Hurricane Planning Commission Meeting Agenda

December 8, 2022
5:00 PM

Agenda Date:	12/08/2022
Application Number:	2022-PP-24
Type of Application:	Preliminary Plat Application
Action Type:	Administrative
Applicant:	Western Mortgage and Realty Co
Agent:	Brent Moser
Request:	Approval of a Preliminary Plat
Location:	South of Sand Hollow Road and West of 3700 W
Zoning:	Recreation Resort and RM-3
General Plan Map:	Planned Community

Agenda Date:	12/08/2022
Application Number:	2022-ZC-38 2022-PSP-47
Type of Application:	Zone Change and Preliminary Site Plan Application
Action Type:	Legislative
Applicant:	Shadow Glen 420 Inc
Agent:	Frank Lindhart
Request:	A Zone Change from RM-2 and HC to RM-3 and HC with a PDO
Location:	100 N 2600 W
Zoning:	RM-2 and HC
General Plan Map:	General Commercial and Multifamily

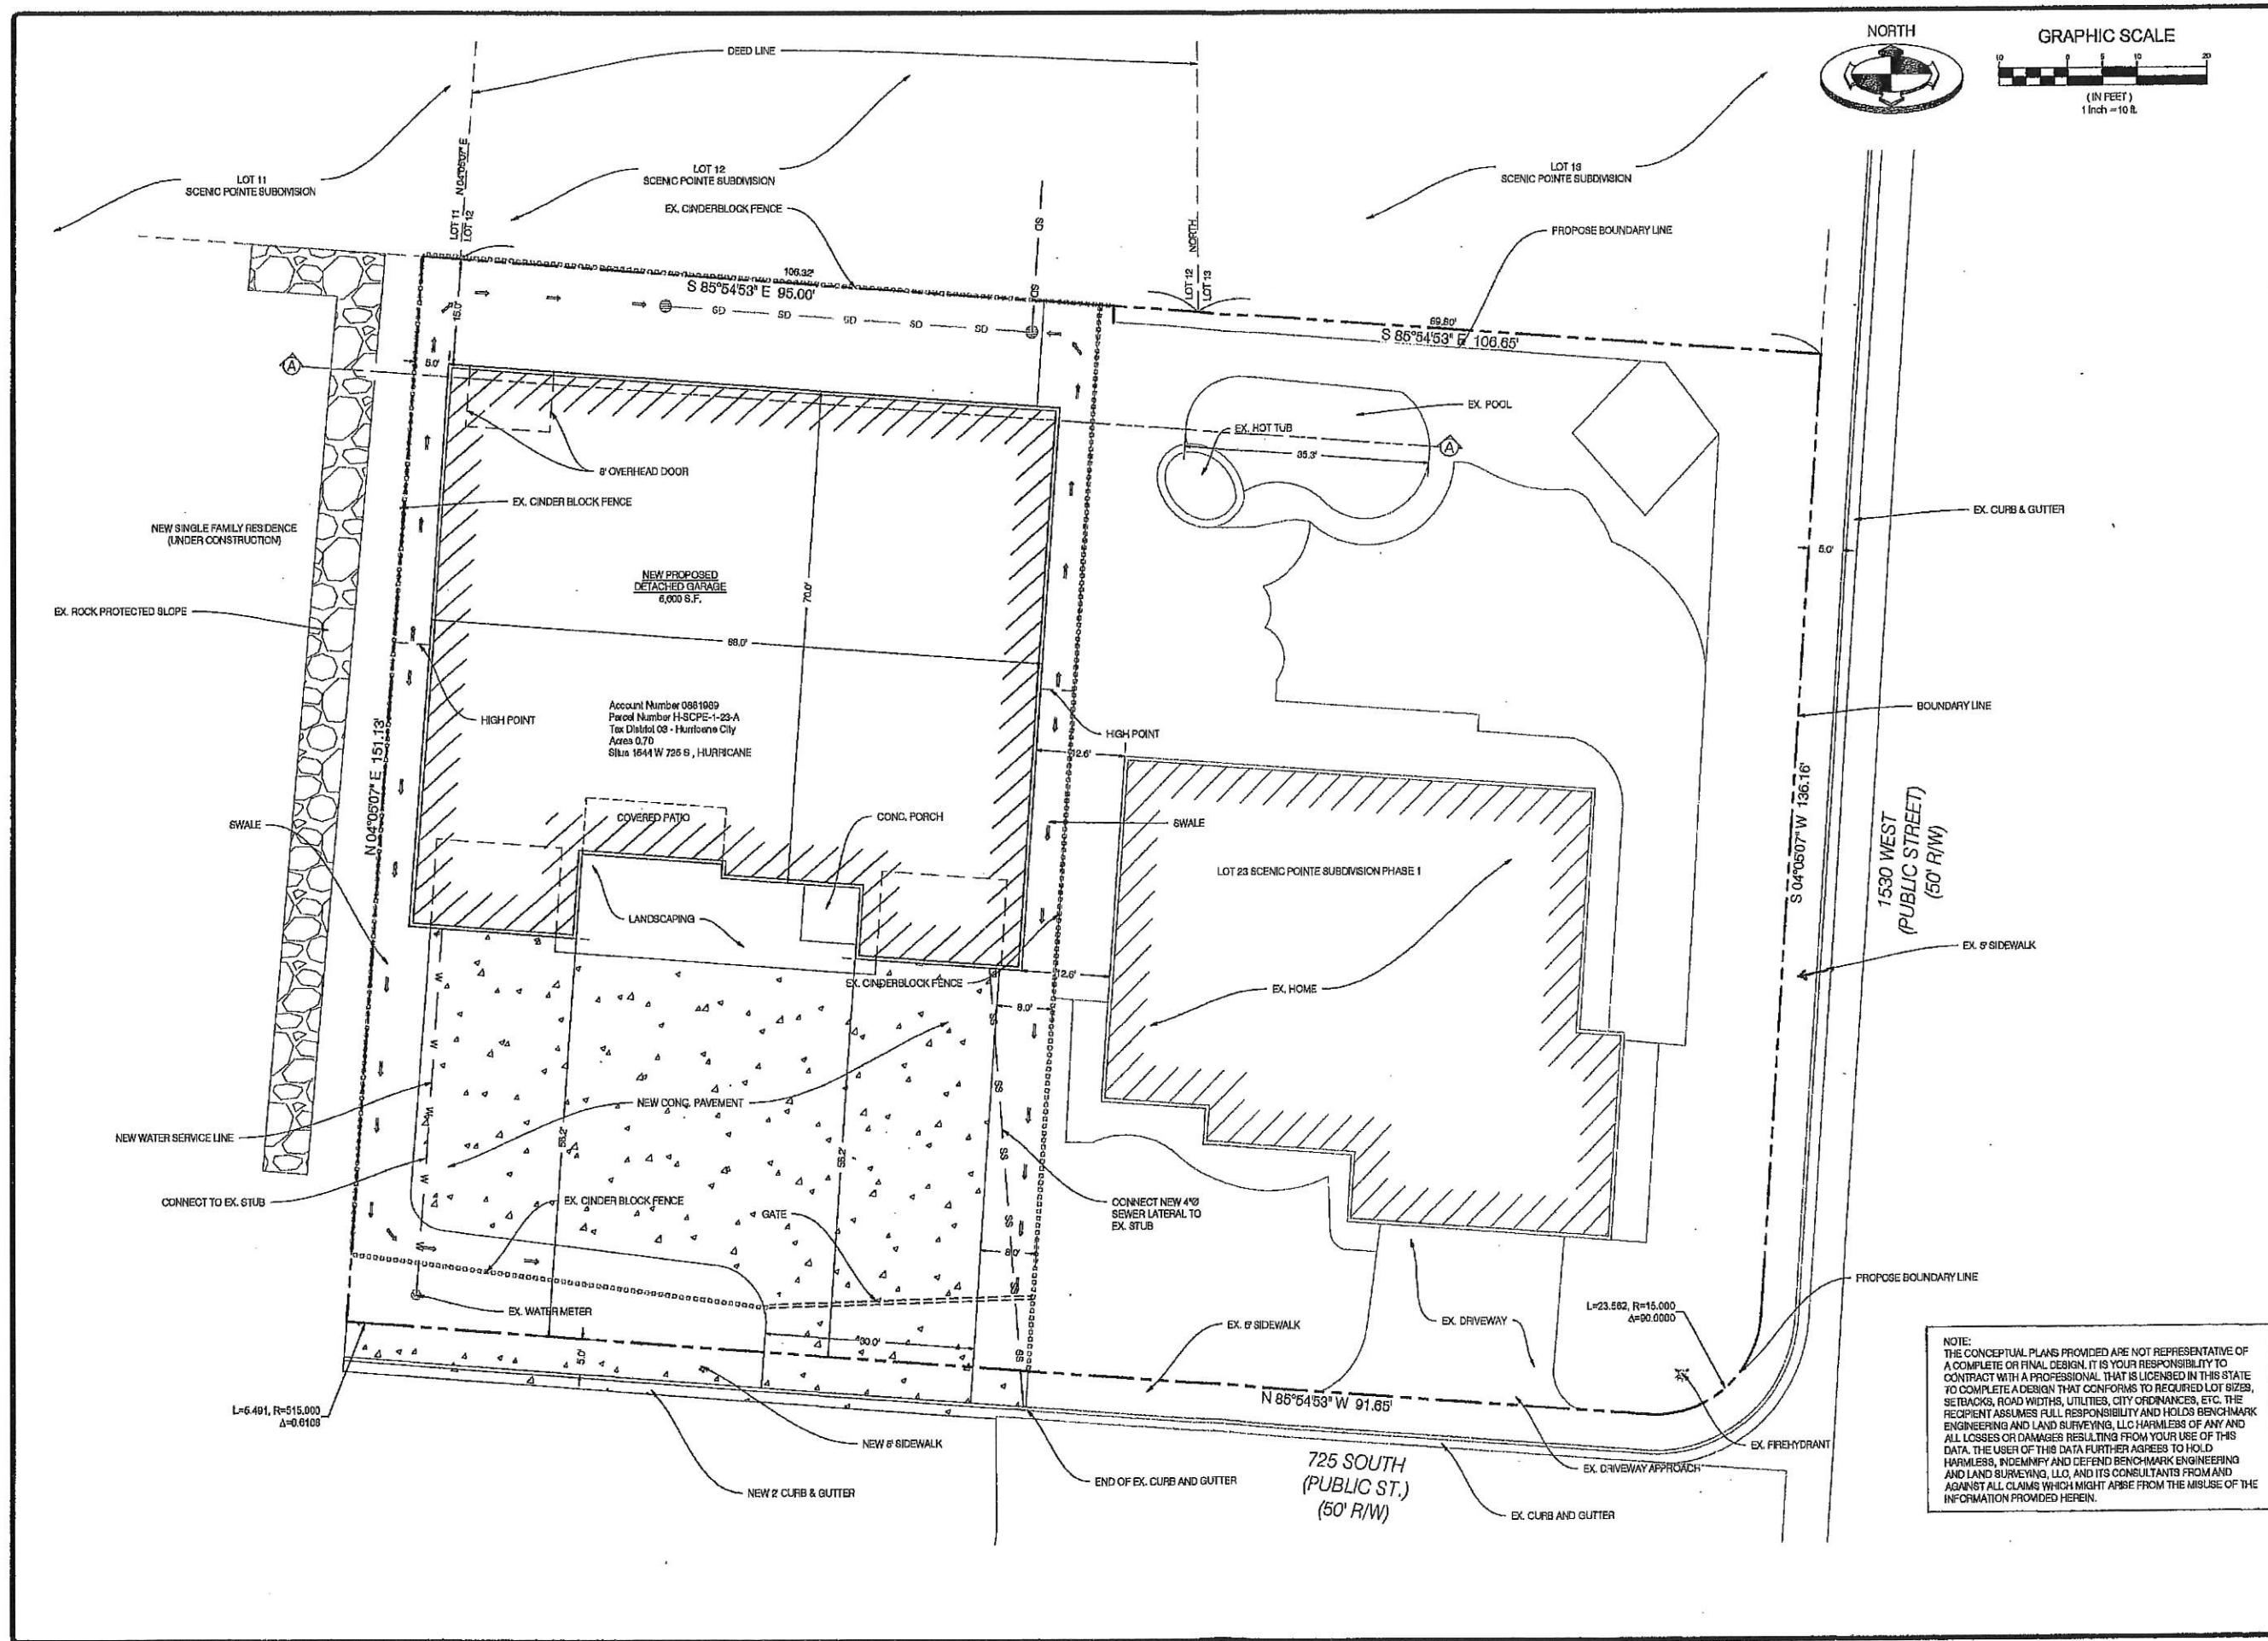
There are several issues the Planning Commission should be aware of: the plan is showing that the garage will be served off existing water and sewer meters on the property. City policy is that only one utility connection per lot and if more are needed than impact fees will need to be paid. As you can see from the satellite photo below, 725 S currently ends where the house ends and the site plan shows a driveway stubbing into a road that does not currently exist. These two parcels were never officially combined as one parcel, just changed parcel numbers for tax purposes. The building does not meet the setbacks to sit on its own lot. An amended final plat is required to actually make this one lot. Finally, the proposed garage is larger than the adjacent home. Staff has expressed concern in the past when buildings this large are proposed because it may violate HCC 10-41-4: *“Secondary use. The accessory dwelling unit shall be clearly incidental and secondary to the primary use of the dwelling for residential purposes.”* However, this building is clearly meant to be a garage first and foremost and living space secondary.

2022-PSP-46

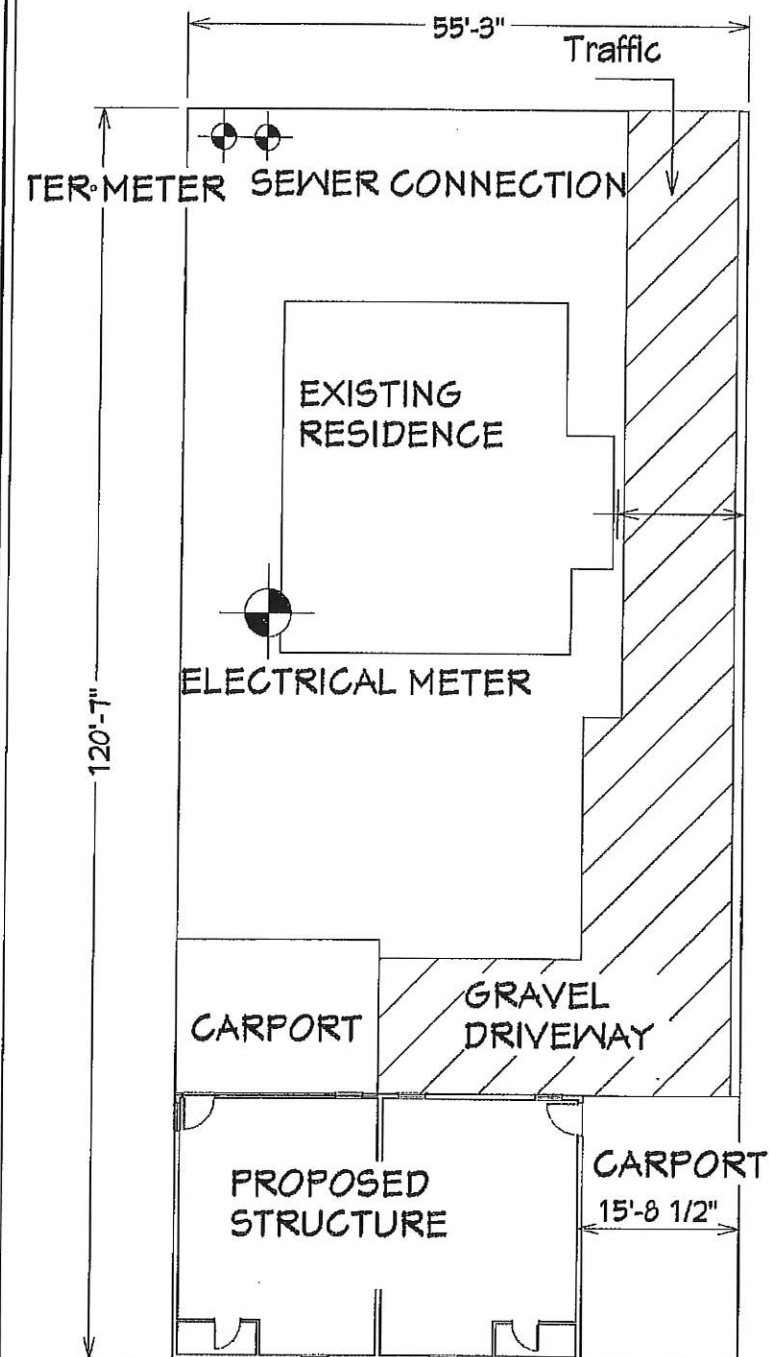
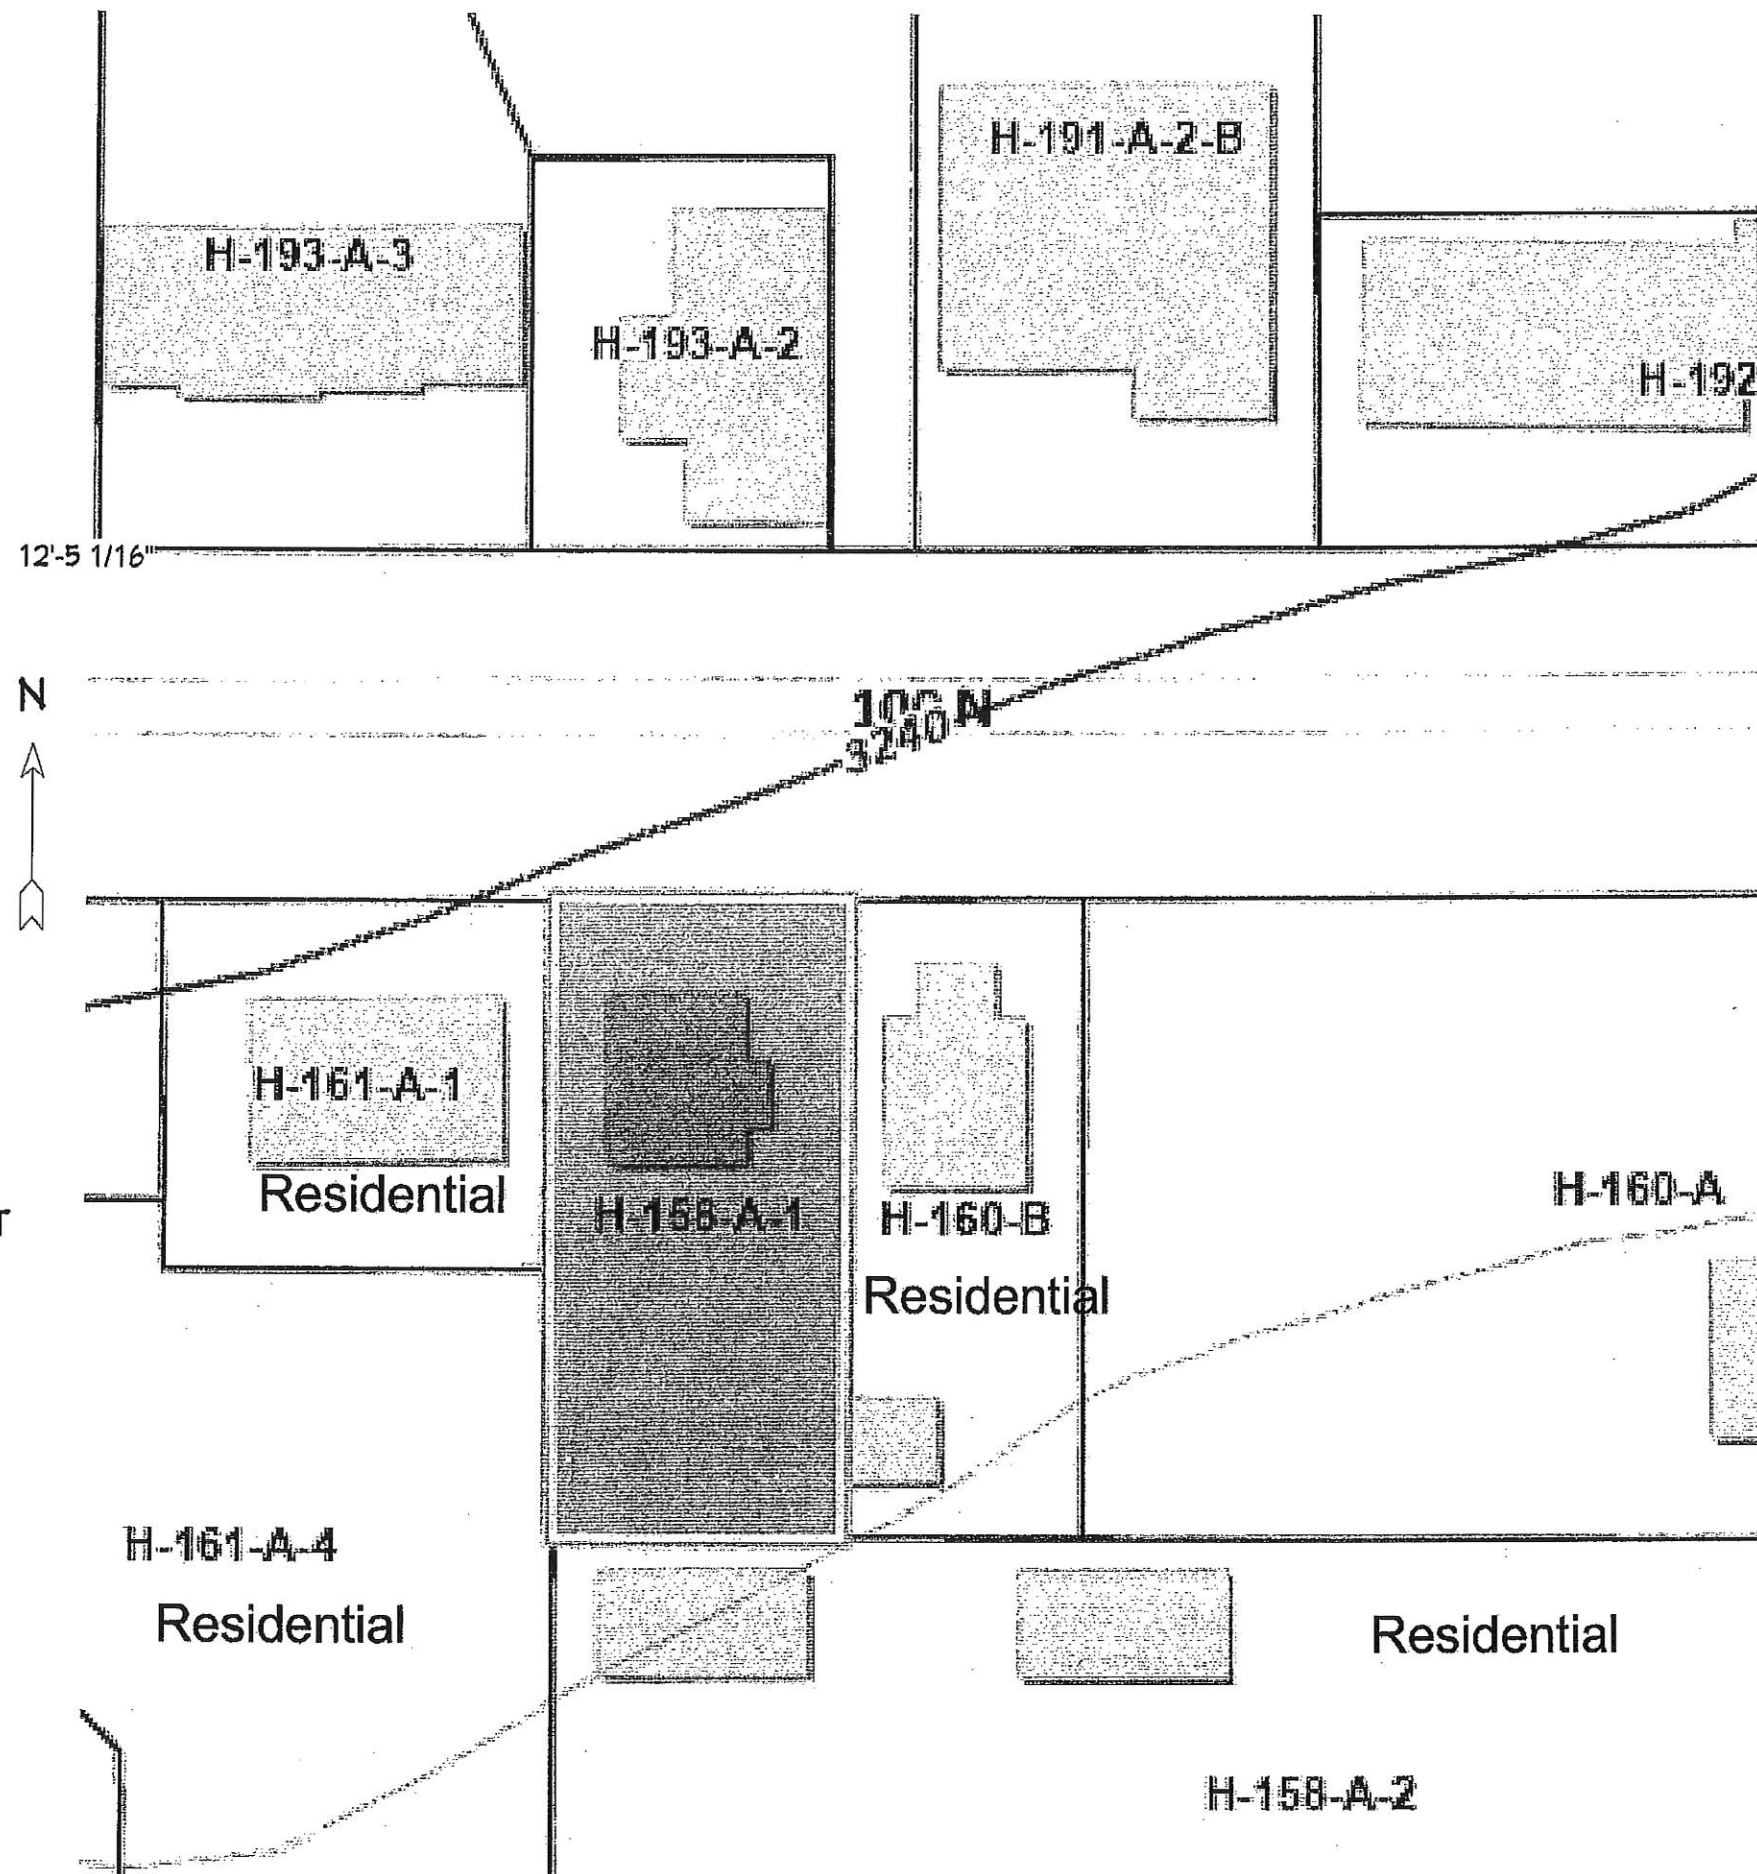
The property to the south is currently used as a vacation rental complex so the zero setbacks shown on the site plan are fine, however the property to the west is currently a residence so a 10 foot setback is required.
